Project	IEEE 802.16 Broadband Wireless Access Working Group < http://ieee802.org/16 >	
Title	Correct Figure for TEK management in BS and MS	
Date Submitted	2005-07-15	
	Sangwoo Doe, Sungsoo Oh, SungHo Yoo POSDATA Co. Ltd.	doeing@posdata.co.kr
Re:	Response to Sponsor Ballot on IEEE802.16e/D9 document	
Abstract	Correct Figure for TEK management in BS and MS	
Purpose	To incorporate the figure changes proposed in this contribution into the 802.16e/D9 draft	
Notice	This document has been prepared to assist IEEE 802.16. It is offered as a basis for discussion and is not binding on the contributing individual(s) or organization(s). The material in this document is subject to change in form and content after further study. The contributor(s) reserve(s) the right to add, amend or withdraw material contained herein.	
Release	The contributor grants a free, irrevocable license to the IEEE to incorporate material contained in this contribution, and any modifications thereof, in the creation of an IEEE Standards publication; to copyright in the IEEE's name any IEEE Standards publication even though it may include portions of this contribution; and at the IEEE's sole discretion to permit others t

Figure 134 -TEK management in BS and SS

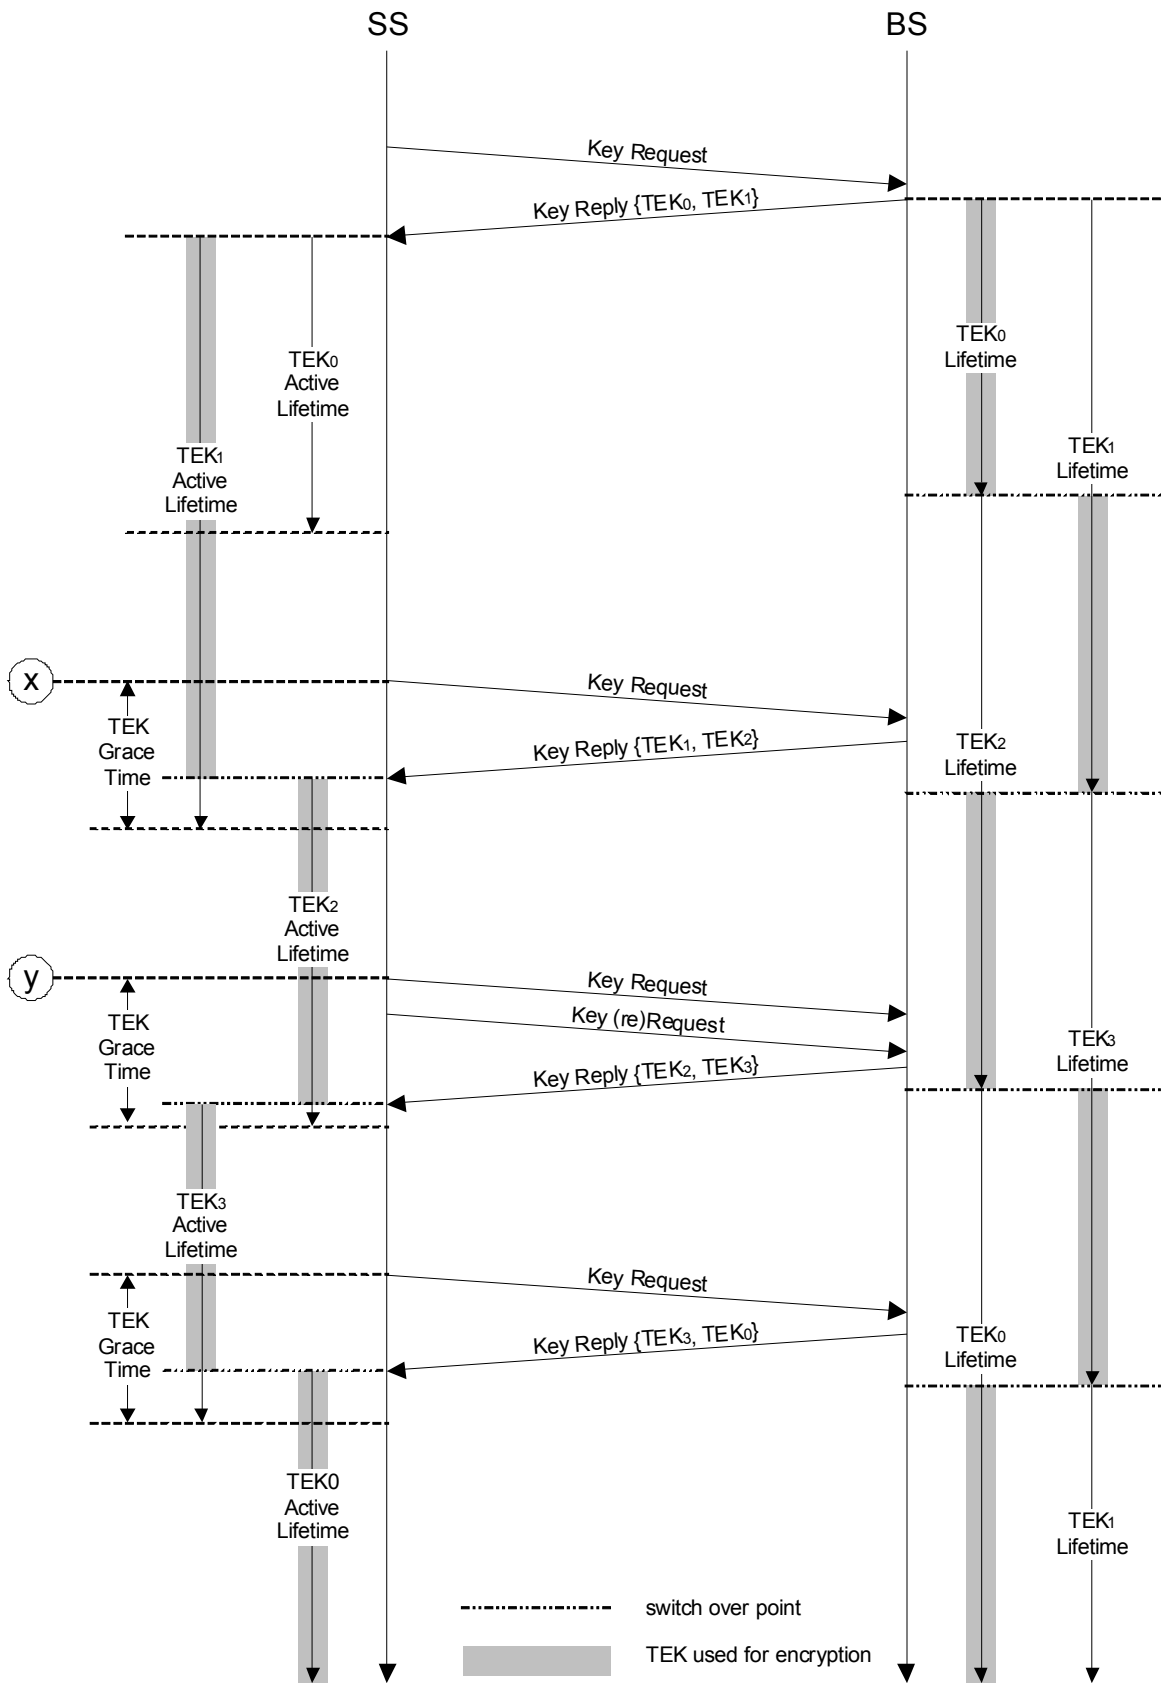
“Through operation of its TEK state machines, an SS shall request a new set of traffic keying material a configurable amount of time, the *TEK Grace Time* [see points (x) and (y) in Figure 134], before the MS's latest TEK is scheduled to expire.” However, Figure 134 is incorrect.

We suggest a correct figure as follows.
